December 30, 1992 11:31

Reference: Addendum to Phase II Site Investigation
Work Plan, Pacific Dry Dock Yard I,
1441 Embarcadero, Oakland, California;
Versar Project No. 1457-027

<p>Scale (feet)</p>	<p>Proposed Ground-Water Monitoring Well Locations</p> <p>Pacific Dry Dock Yard I Oakland, California</p>	<p>Figure 3</p>
<p>Project No. 1457-027</p>		<p>Versar Inc.</p>

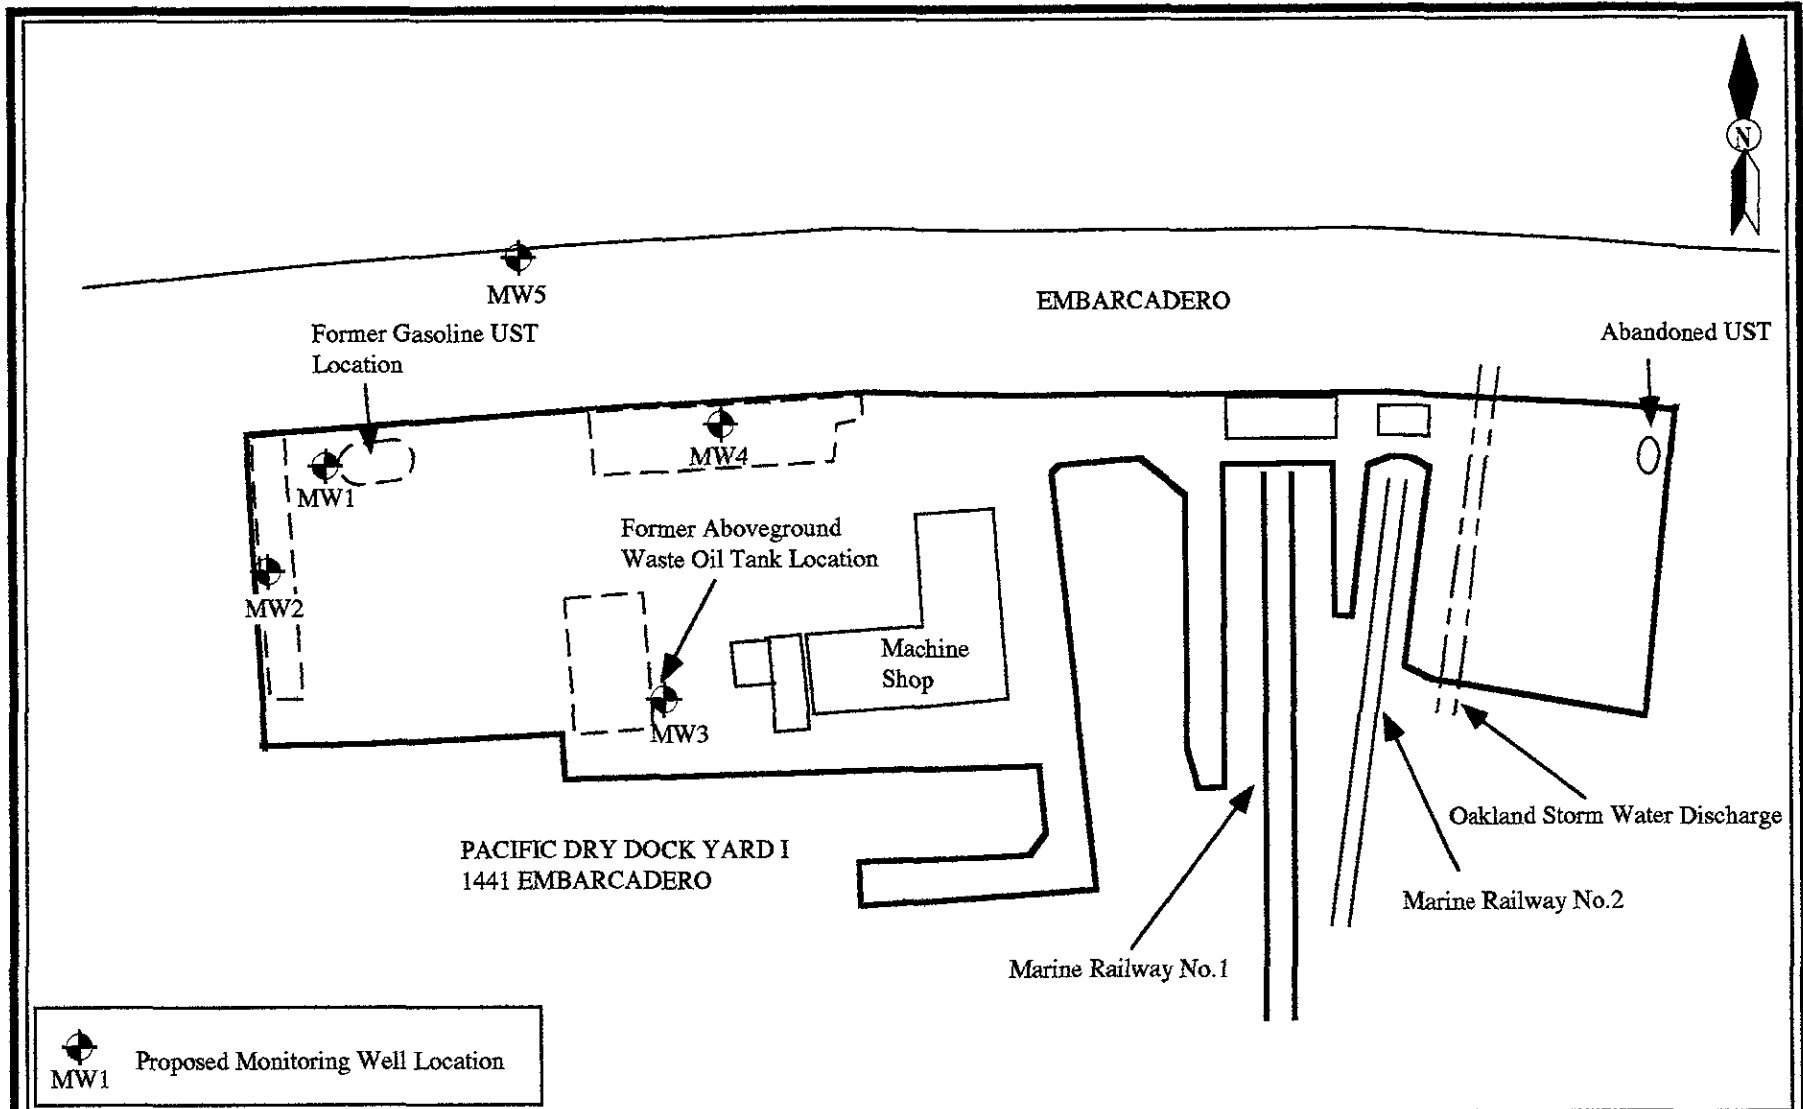
To determine the extent and concentration of contaminants in the ground water beneath the site, five two-inch inside diameter ground-water monitoring wells will be installed. The monitoring wells will be installed as described in section four of the Phase II Work Plan. However, the well locations will be different from those proposed in the work plan. The revised proposed locations are presented in Figure 3, Attachment I. As shown in Figure 3, the location of the offsite well has been moved to the opposite side of the Embarcadero. The remaining wells are located along the north and west property boundaries (near the location of the

previously removed gasoline UST) and near the former location of the waste oil tank. The encroachment permit previously acquired for the Embarcadero well is being resubmitted with the new well location. Excavation and well installation permits will be acquired prior to drilling.

Figure 4

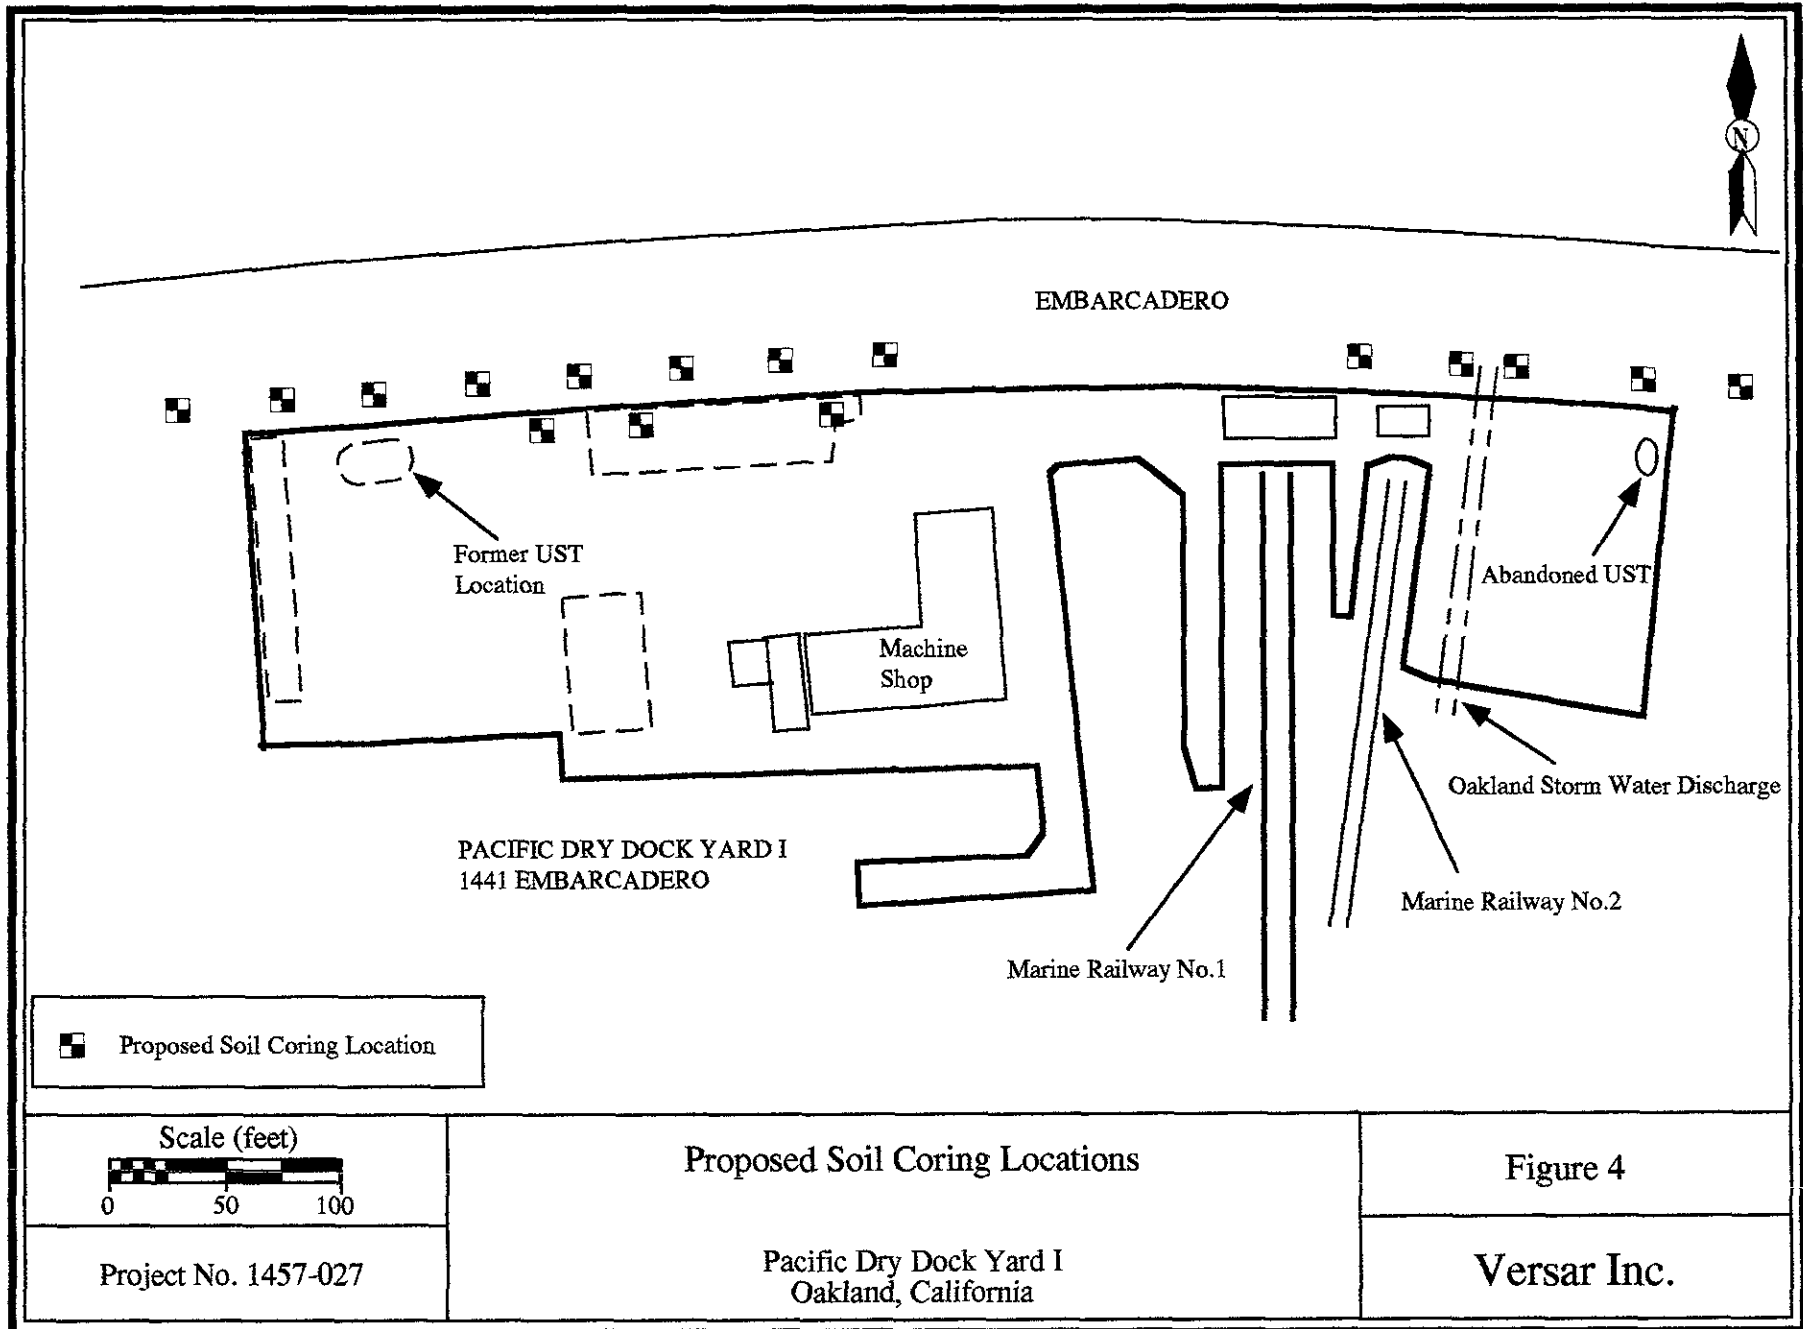
Following installation of the monitoring wells, approximately 16 boreholes will be cored at the site. The proposed coring locations are shown in Figure 4, Attachment I. Thirteen of the borehole locations are in the Embarcadero, just north of the sidewalk. The remaining four proposed locations are along the north edge of the site, at or near the former location of the office. The proposed locations are subject to change, however, based on the results of the monitoring well investigation and access restrictions due to subsurface utilities. An excavation permit will be acquired prior to initiation of coring activities.
